Hello members of the Urban Design Committee and the Planning Commission,

I have a number of comments to make on UDC 2020-11, the Route 1 intersection changes, concerning buses, bus lanes, turn lanes, crosswalks and a general comment on these kinds of projects. I hope these comments are helpful in making this project safer.

Figure 1: Using the crosswalk requires crossing two directions of traffic with no separating median, a violation of good design principles

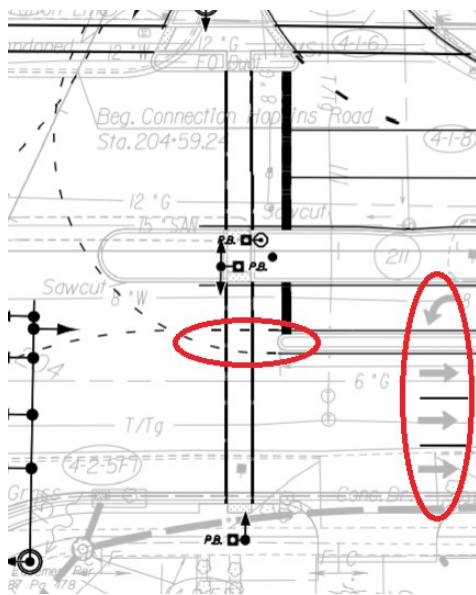
2. **The channelized left turn lane from southbound Route 1 onto Harwood is dangerous.** Look at pg 77 of the Location Plans and note that someone crossing Route 1 on the north side of the intersection from east to west will involve first crossing 3 northbound lanes and then one southbound left turn lane before reaching the median. This violates the common traffic

“Medians convert a two-way movement into two one-way movement. Improvement is safer for pedestrians. ‘Look left and cross, then ...look right and cross.’”<sup>1</sup> In this section there are actually two medians, one on each side of the left turn lane, but only one of them extends to the crosswalk. That the crosswalk will only be active when the left turn signal is red should be of no matter, as given the expected long light cycle time frustrated people walking will likely cross on red when there is no traffic coming from one direction, and if they miss noticing that this half crossing actually requires them to look in two opposing directions they are more likely to be hit. **Either the second, smaller median should be extended to include the crosswalk, or the left turn lane should be redesigned to be on the west side of the larger median.**

*Figure 2: The gentle curve in the right turn slip lane is designed for high speeds, even though this leads into a residential neighborhood with high rates of walking*

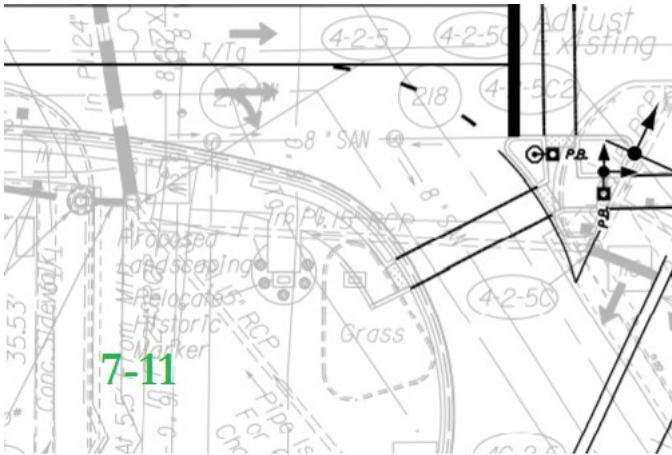
3. **The addition of right-turn slip lanes will speed traffic through these intersections, harming the safety of people walking and driving that the project is ostensibly aimed to do.** Again

skew of the new intersection, that **without a slip lane cars would have to slow to a crawl to make the turn. And indeed, that is the point!** It is good that cars would have to slow. There are many skewed intersections in Richmond without a slip lane that see significant traffic, such as Lombardy and Brook, or Westwood and Arthur Ashe, but there are also many sharper skewed turns on Harwood itself today, such as onto Bowen/21st, Mason, Keswick and Joslin! If a vehicle can make those turns, it can make this one too. Further, trucks are prohibited on Harwood, and trucks over 7500 lbs are prohibited on Keswick, which will have access from Route 1 closed anyway, so there should be no trucks making this right turn onto Harwood at all. However, the 3C GRTC bus does make a right turn onto Harwood evenings and Sundays. It would be better to reroute this bus northbound from Route 1 to Mimosa and then Lynnhaven or Overlook; while a few stops would be missed on Route 1, these mostly service industrial locations that are unlikely to need service during the few hours the 3C runs. **The slip lanes should be removed, particularly turning onto Harwood, and if necessary the GRTC 3C should be rerouted, but if even with that reroute the lanes absolutely need to stay (they don't!), they should be redesigned with sharper angles to slow traffic as in the FHWA document<sup>3</sup> and this design guideline.<sup>4</sup> The safety of people walking should not be compromised for the slight convenience of people driving.**

see pg 77. Cars are going to speed through this intersection, directly adjacent to a 7/11 that is frequented by many lower income people in the neighborhood, which includes one of Richmond's public housing communities. To quote the Federal Highway Administration: "The problem for pedestrians is that many slip lanes are designed for unimpeded vehicular movement. Islands for the right-turn slip lanes should be designed instead to discourage high-speed turns[.]"<sup>2</sup> I expect the applicant will say that the right turn is too tight due to the
